PREPARED FOR THE PLAN COMMISSION

Project Address: 222 N. Charter Street (District 8 – Ald. Wood)
Application Type: Planned Development Zoning Map Amendment
Legistar File ID # [50129](#) and [49807](#)
Prepared By: Chris Wells, Planning Division
Report Includes Comments from other City Agencies, as noted
Reviewed By: Kevin Firchow, AICP, Principal Planner

Requested Action: There are two requests before the Plan Commission: 1) A Planned Development zoning map amendment to change the zoning of property generally located at 222 N. Charter Street from TR-U2 (Traditional Residential - Urban 2) District to PD(GDP-SIP) (Planned Development (General Development Plan, Specific Implementation Plan)) District; and 2) a Demolition Permit to demolish the single-family residence located at 222 N. Charter Street in order construct a 12-story, 43-unit apartment building.

Image 1: Floor Plans (Areas Inconsistent with Plan are Shaded)

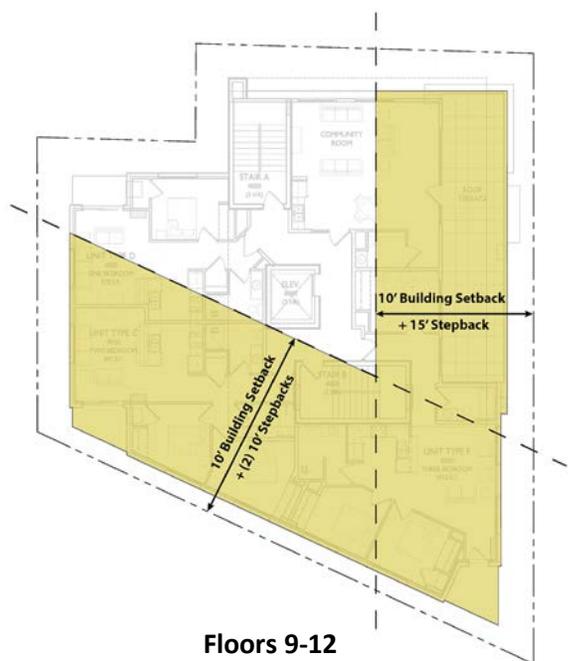
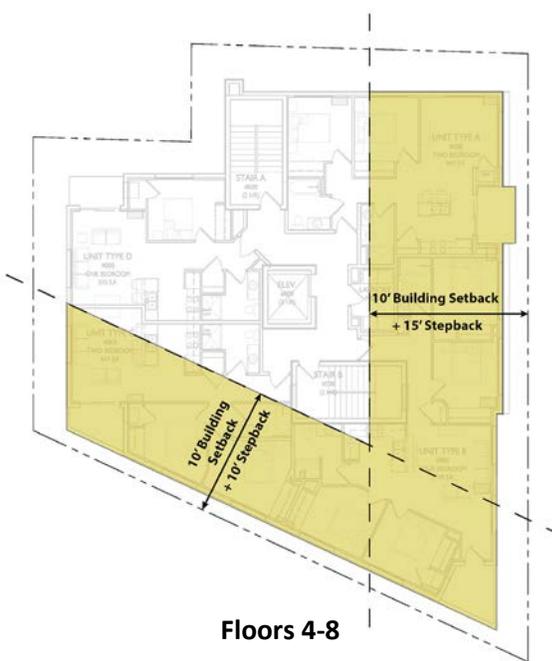
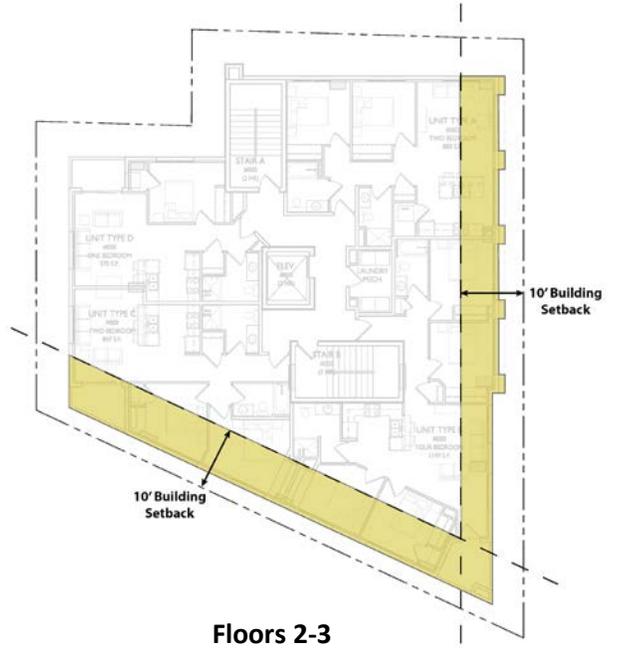
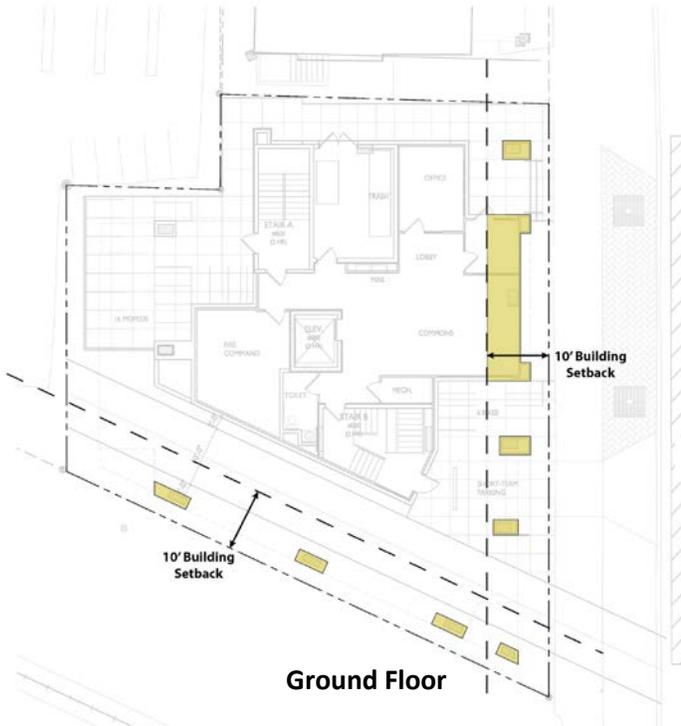
However, the project remains inconsistent with several detailed setback and stepback recommendations in the plan. In total, approximately 27,500 of the roughly 51,000 square feet of above-ground proposed building space square feet or roughly 53 percent of the building, is located within the recommended setback and stepback areas.

Along Charter Street, the plan recommends a 10-foot street setback with additional 15-foot stepback above the third floor. As proposed, only some portions of the Charter Street ground floor façade comply with the recommended setback. This includes the main entrance and covered arcade features as shown in the submitted plans. The rest of the ground floor façade is set back just three feet. For the upper stories, the setback is 3-4 feet for Floors 2-3 and 4-5 feet for Floors 4-12.

Along the adjacent rail line, the plan recommends a minimum 10-foot building setback. A ten-foot stepback is called for above the third floor with an additional 10-foot stepback above the eighth story. The Plan also recommends that parking facilities should be set back at least 10 feet from the property line. While the majority of southerly ground floor façade sits roughly 18.5 feet back from the property line, columns to support the upper floors are set back 2.5 feet. The upper floors along this elevation sit 2.5 feet back.

Please See **Attachment 1** for a graphic comparing this proposal to these recommendations.
